ADDENDUM NO. 2

DATE OF ISSUANCE:	April 22, 2024
PROJECT:	2024 Addition and Renovations North Harrison Elementary School 1115 W. Whiskey Run Road Ramsey, IN 47166
OWNER:	North Harrison Community Schools
ARCHITECT'S PROJECT NO.:	23-228.001
ORIGINAL BID ISSUE DATE:	April 03, 2024

PARTIAL FIRST FLOOR PLAN - LIGHTING - ALTERNATE NO. 3

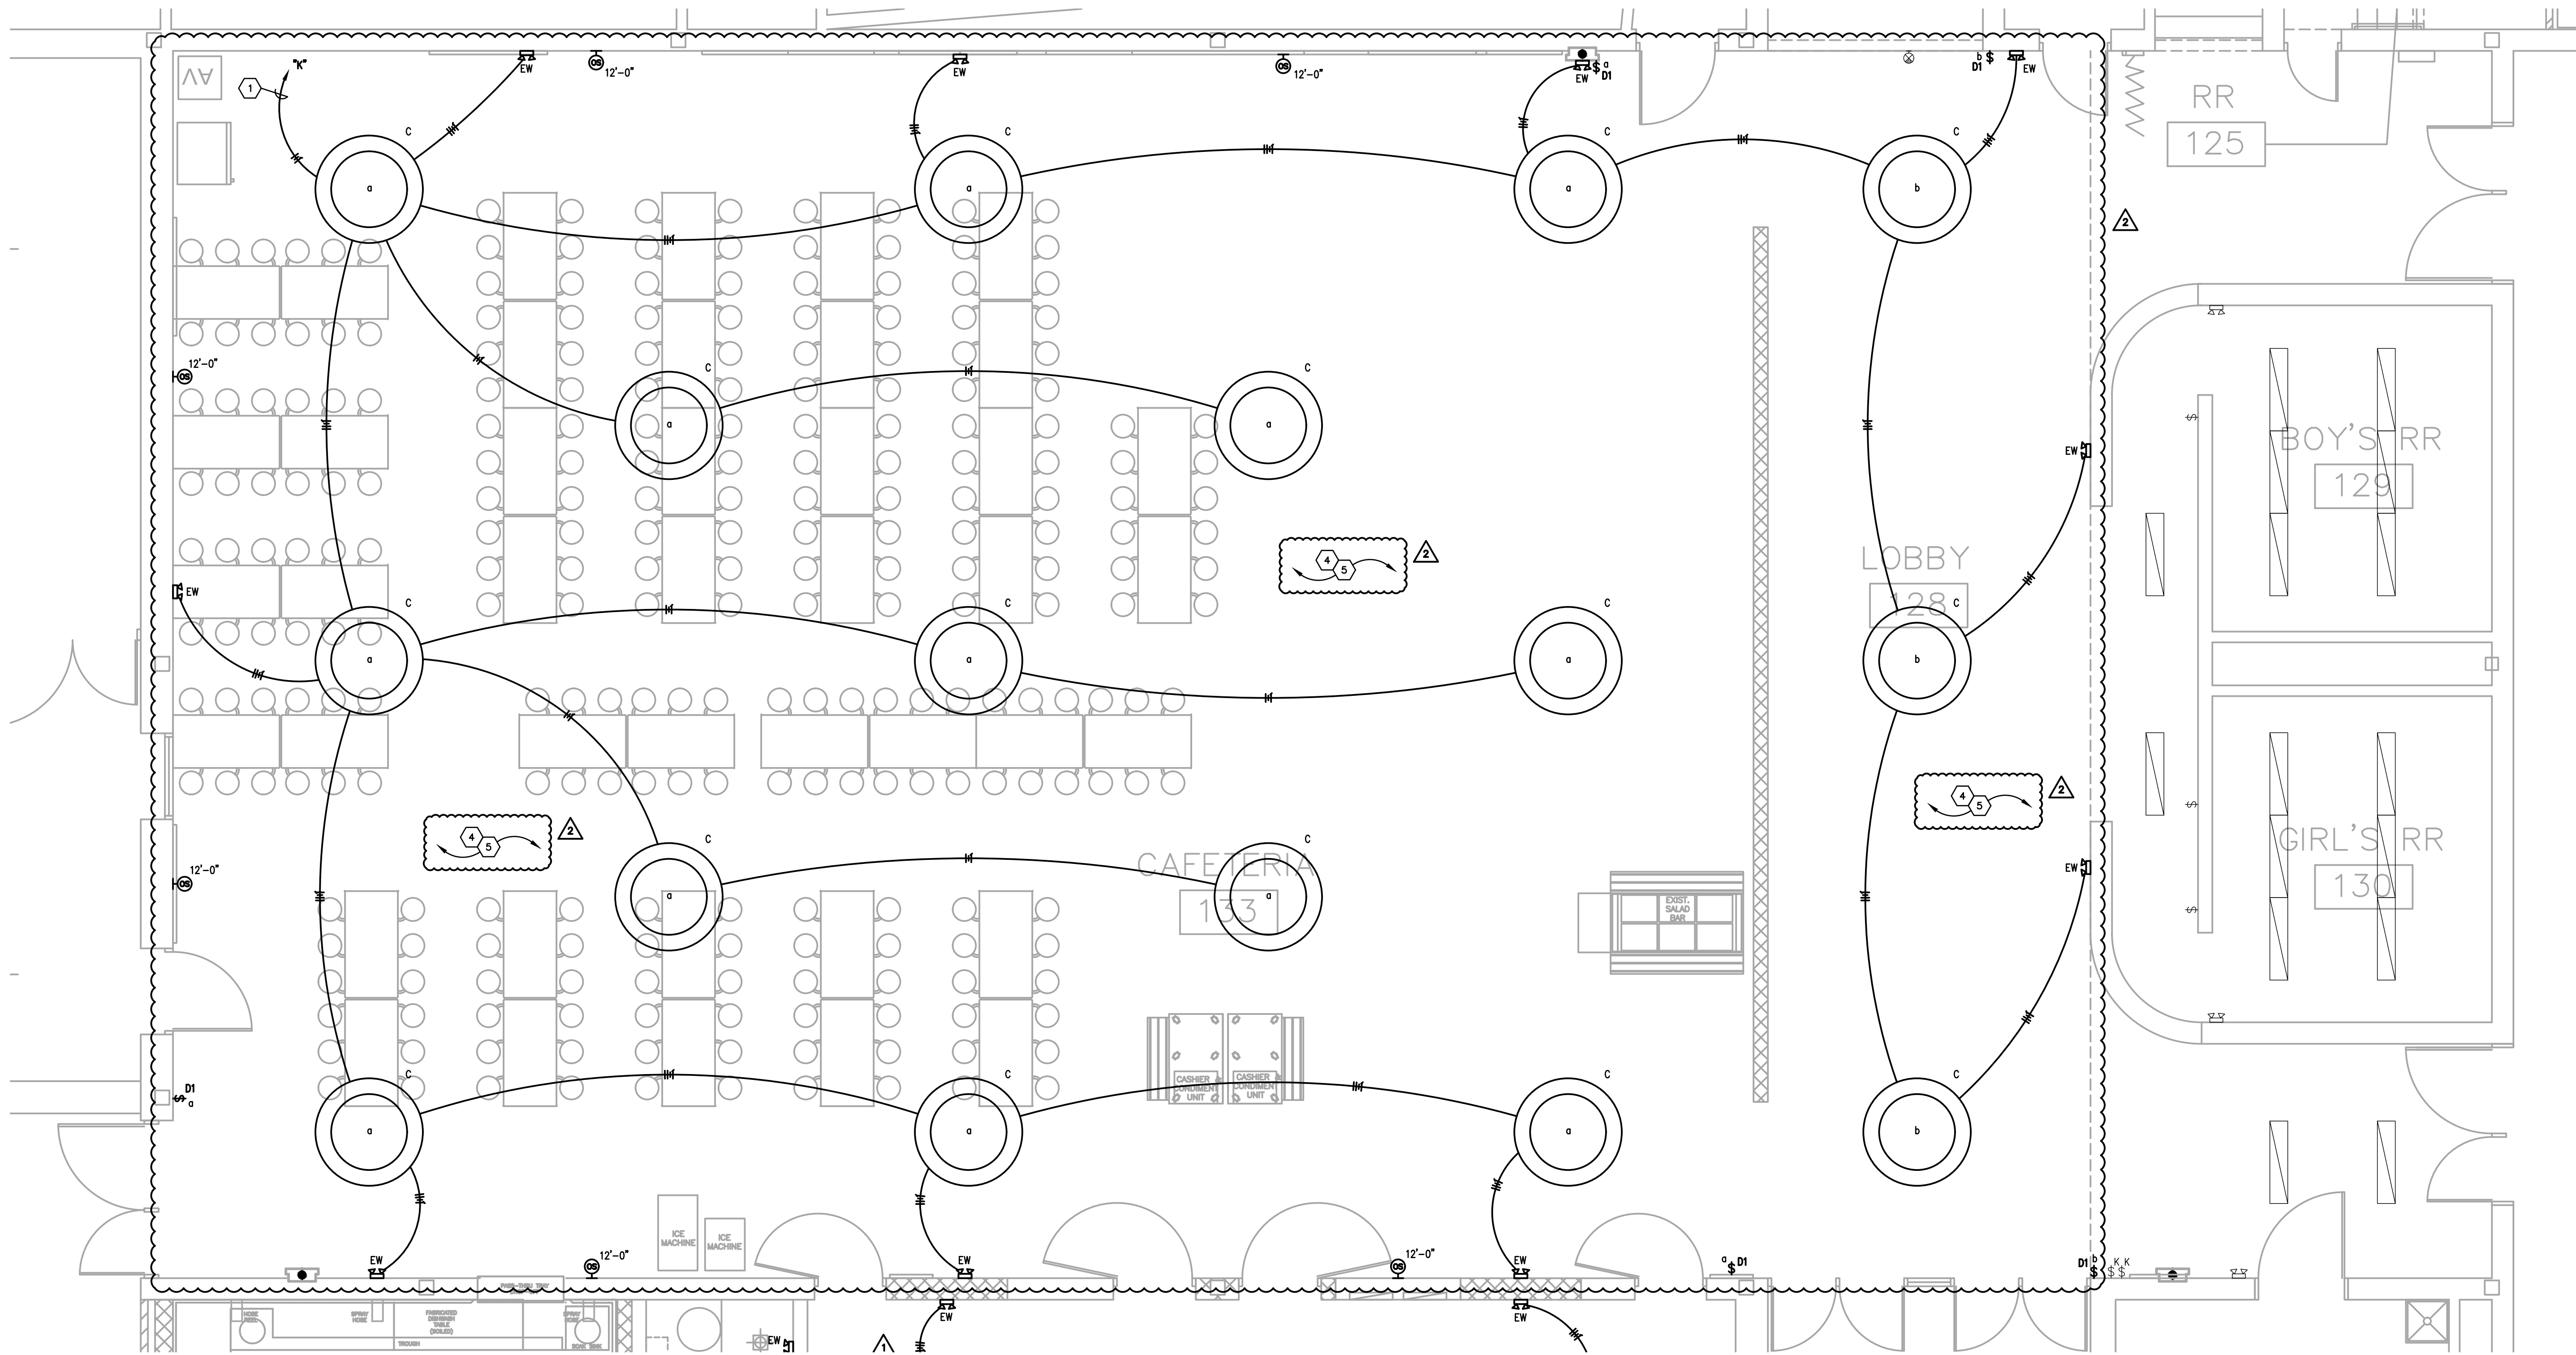
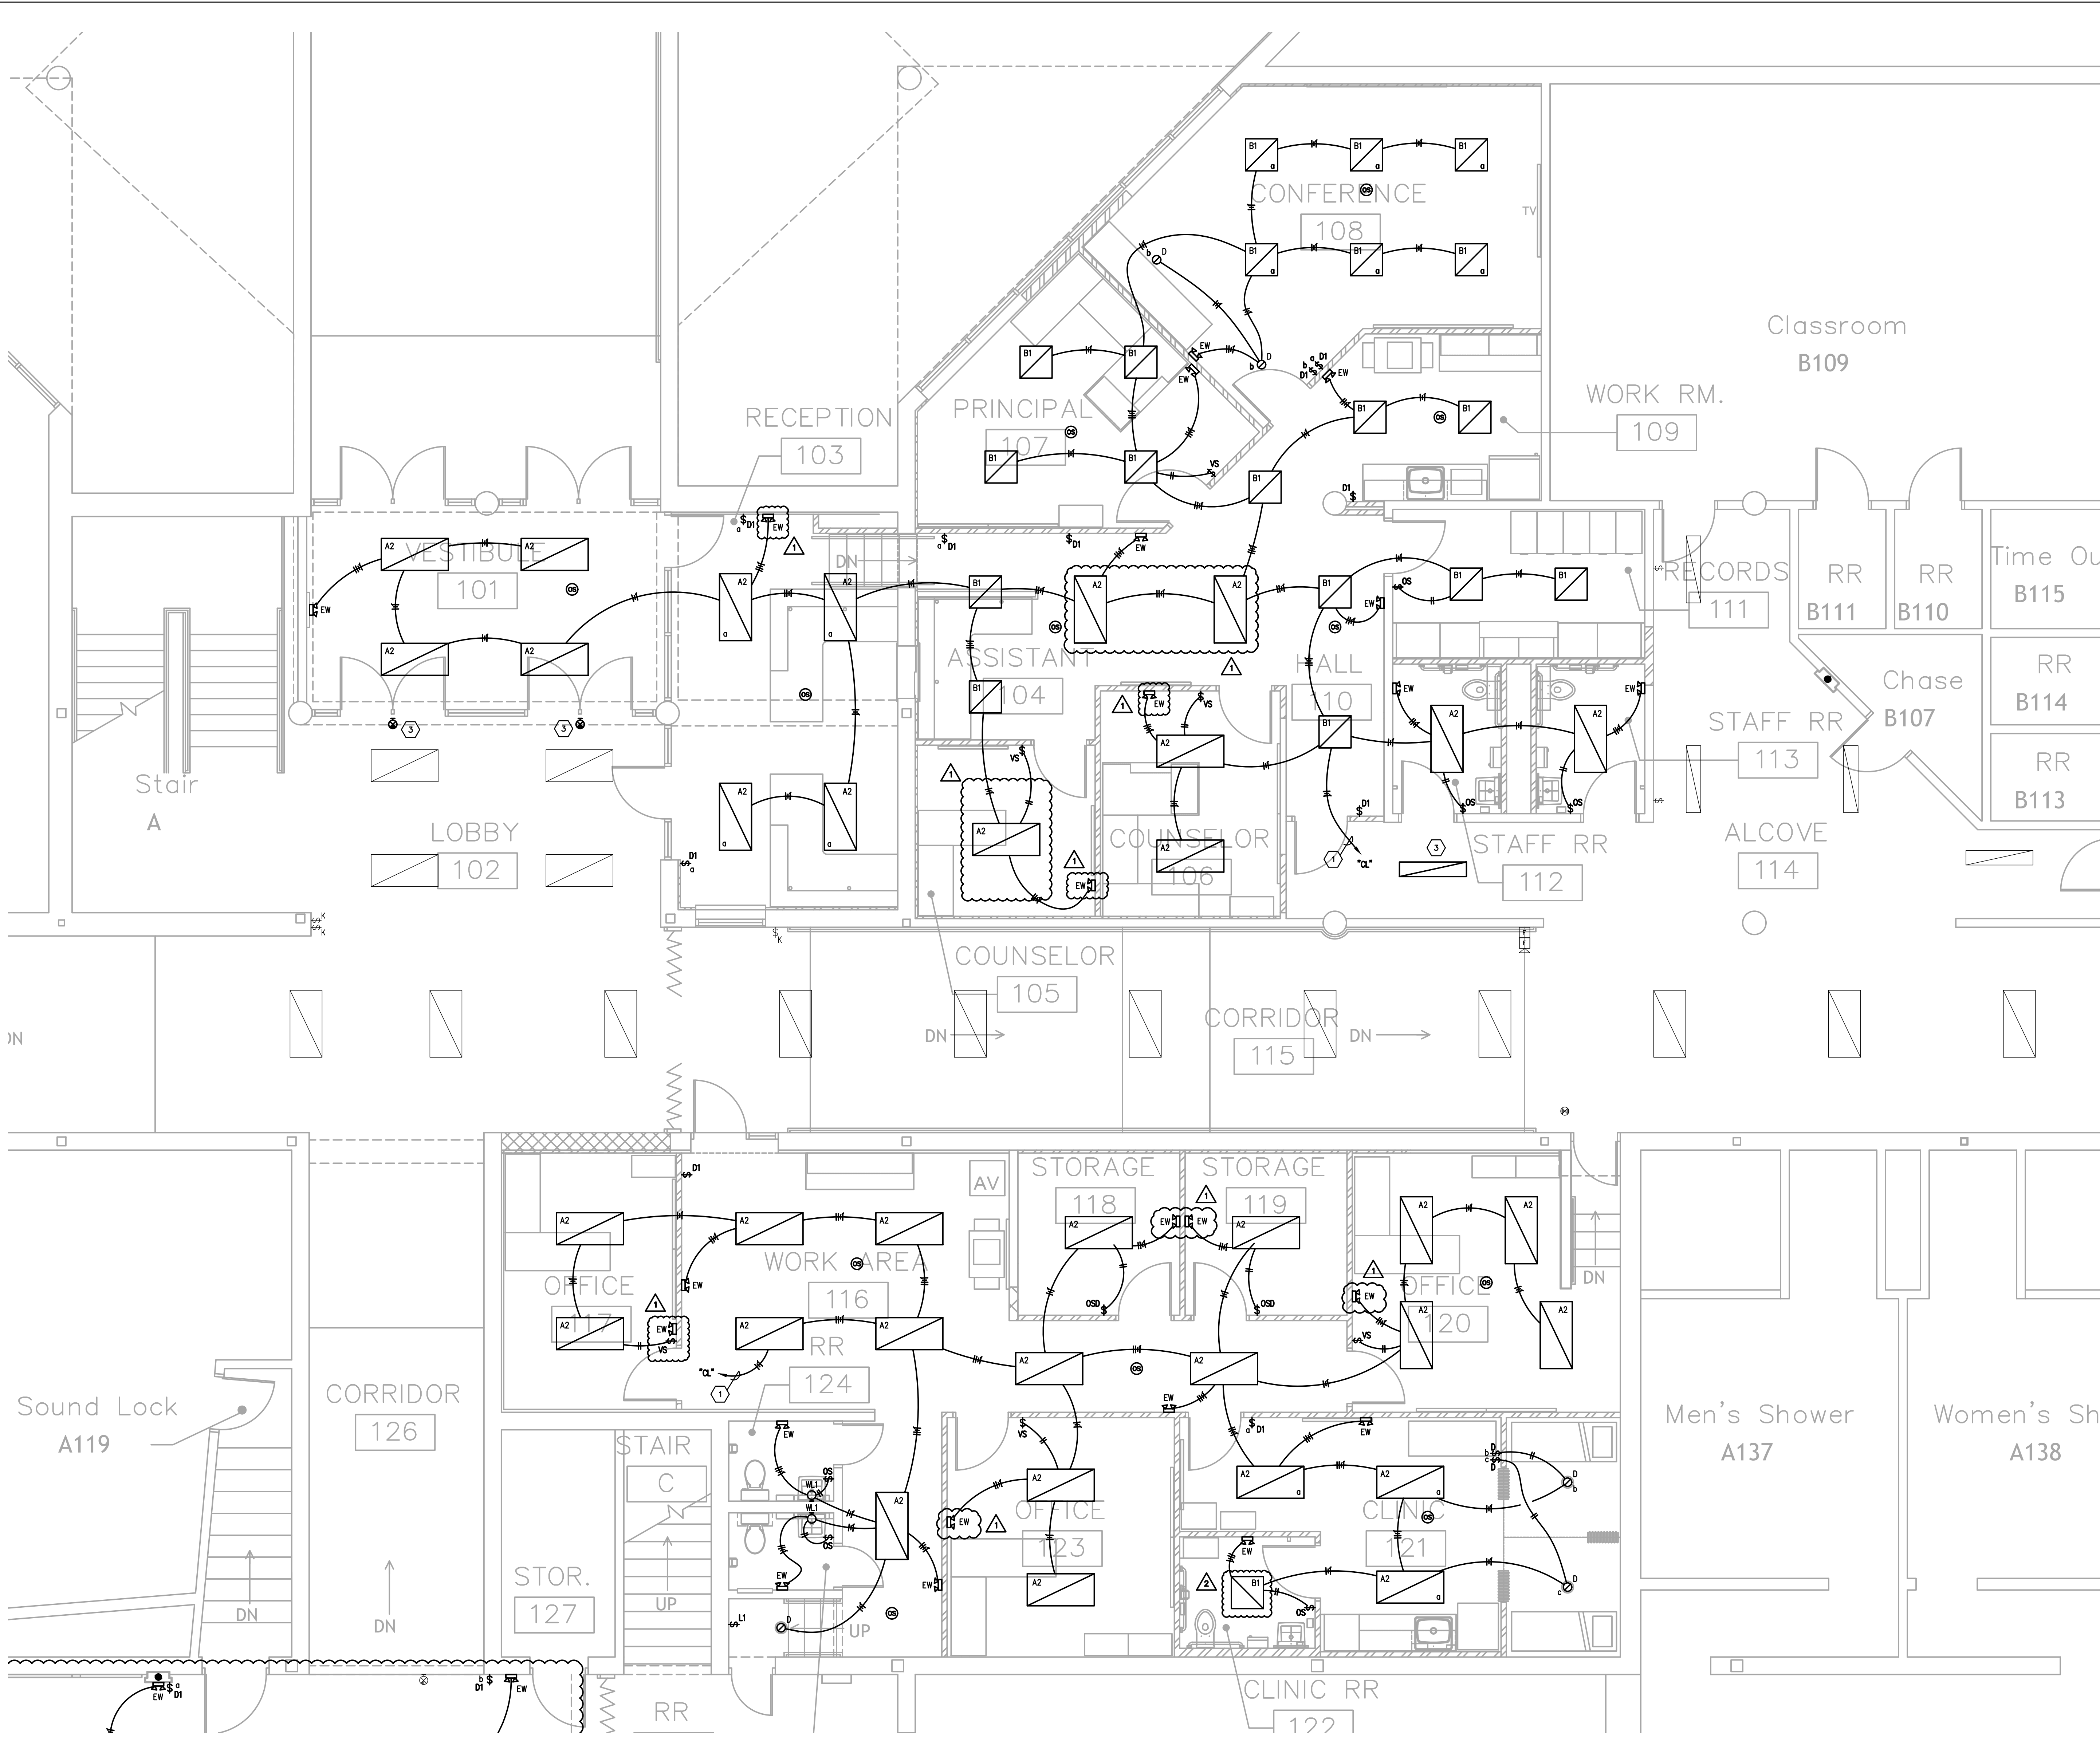
ADD-2 Item No. S-4 - Alternate No. 3

1. Give the amount to be **DEDUCTED** from the Base Bid for the following:
 - a. Deduct ring pendant light fixtures Type 'C' in Cafeteria 133 as shown on Partial First Floor Plan – Lighting - Area B on Drawing E300B.

ADD-2 Item No. D-18 - Cafeteria 133 and Lobby 128 Lighting Layout and Alternate Layout

- Refer to sheet for new lighting layout with 60"D ring fixtures instead of 72"D ring fixtures.
- Refer to lighting alternate layout [Alternate #3] using linear fixtures on the sheet indicated.
